Access Compliance Report

Public Rights-of-Way

(Curb Ramps)

Intersection ID: 26839	Main Street: OLD_COURSE_DR	Cross Street: PREMIER_DR	Location: SW
ADA ID: 3C44A4A6E9D1	Ramp Type: PerpDiag	Initial Pass/Fail: Fail	Overall Compliance: No
Severity Score: 21.25			
Codes/Mitigation Info/Possible Solution		Field Measurements/Component Compliance

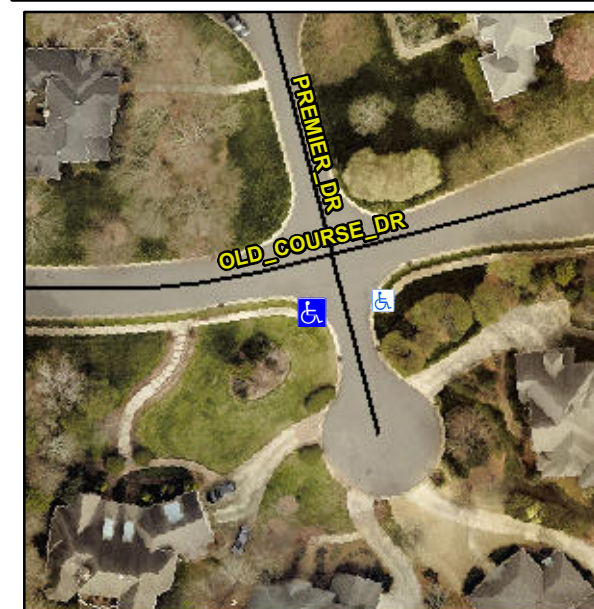
R304.5.1, R304.2.2

Compliance	Description	Data	Compliance	Description	Data
N/A	Ramp Length (in)	95.0	No	Ramp Slope (%)	8.4
No	Ramp Width (in)	39.5	Yes	Ramp XSlope (%)	0.2
N/A	Flare Type LT	N/A	N/A	Flare Type RT	N/A
N/A	Flare Slope LT (%)	N/A	N/A	Flare Slope RT (%)	N/A
N/A	Flare Traversable LT?	N/A	N/A	Flare Traversable RT?	N/A
N/A	Landing Length (in)	N/A	N/A	DWS Provided?	N/A
N/A	Landing Width (in)	N/A	N/A	DWS Contrast?	N/A
N/A	Landing Slope (%)	N/A	N/A	DWS Length (in)	N/A
N/A	Landing X Slope (%)	N/A	N/A	DWS Full Width?	N/A
N/A	Landing Curb? (Y/N)	N/A	N/A	DWS Offset (in)	N/A
N/A	Shared Landing?	N/A			
N/A	Gutter Ponding?	N/A	N/A	Gutter Slope (%)	N/A
N/A	Gutter Lip Ht (in)	N/A	N/A	Gutter X Slope (%)	N/A
N/A	Painted X Walk1?	No	N/A	Painted X Walk2?	No
	X Walk 1 Direction	To E		X Walk 2 Direction	To N
N/A	X Walk 1 Width (in)	N/A	N/A	X Walk 2 Width (in)	N/A
	X Walk 1 Slope (%)	0.8		X Walk 2 Slope (%)	0.0
	X Walk 1 X Slope (%)	0.2		X Walk 2 X Slope (%)	1.1

Remove & Replace Curb Ramp With Two New Directional Ramps or Equivalent.
